Access Compliance Report

Public Rights-of-Way

Intersection ID: 52311	Main Street: IMPATIEN_DR	Cross Street: LUPINE_CT	Location: NE
ADA ID: AD69AE7BFBC7	Ramp Type: PerpDiag	Initial Pass/Fail: Fail	Overall Compliance: No
		Severity Score: 10

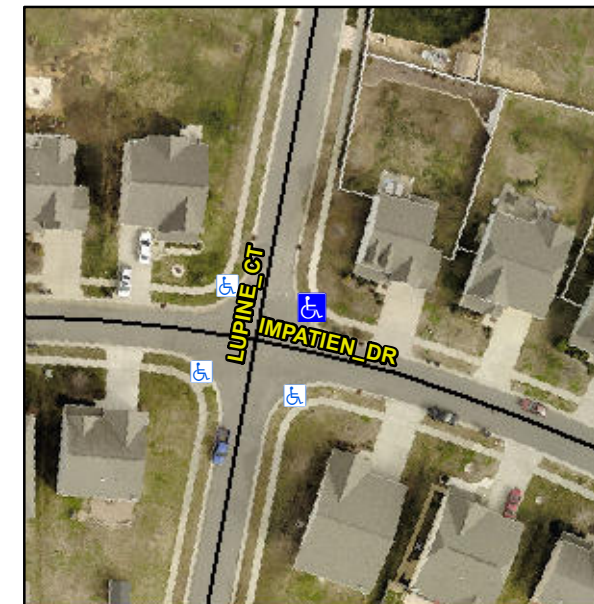
Not Found, R304.5.1, R304.5.3

Compliance	Description	Data	Compliance	Description	Data
N/A	Ramp Length (in)	71.5	Yes	Ramp Slope (%)	5.2
No	Ramp Width (in)	47.0	No	Ramp XSlope (%)	2.8
N/A	Flare Type LT	N/A	N/A	Flare Type RT	N/A
N/A	Flare Slope LT (%)	N/A	N/A	Flare Slope RT (%)	N/A
N/A	Flare Traversable LT?	N/A	N/A	Flare Traversable RT?	N/A
N/A	Landing Length (in)	N/A	N/A	DWS Provided?	N/A
N/A	Landing Width (in)	N/A	N/A	DWS Contrast?	N/A
N/A	Landing Slope (%)	N/A	N/A	DWS Length (in)	N/A
N/A	Landing X Slope (%)	N/A	N/A	DWS Full Width?	N/A
N/A	Landing Curb? (Y/N)	N/A	N/A	DWS Offset (in)	N/A
N/A	Shared Landing?	N/A			
N/A	Gutter Ponding?	N/A	N/A	Gutter Slope (%)	N/A
N/A	Gutter Lip Ht (in)	1.5	N/A	Gutter X Slope (%)	N/A
N/A	Painted X Walk1?	No	N/A	Painted X Walk2?	No
	X Walk 1 Direction	To W		X Walk 2 Direction	To S
N/A	X Walk 1 Width (in)	N/A	N/A	X Walk 2 Width (in)	N/A
	X Walk 1 Slope (%)	3.4		X Walk 2 Slope (%)	2.5
	X Walk 1 X Slope (%)	0.2		X Walk 2 X Slope (%)	1.2

Remove & Replace Curb Ramp With Two New Directional Ramps or Equivalent.
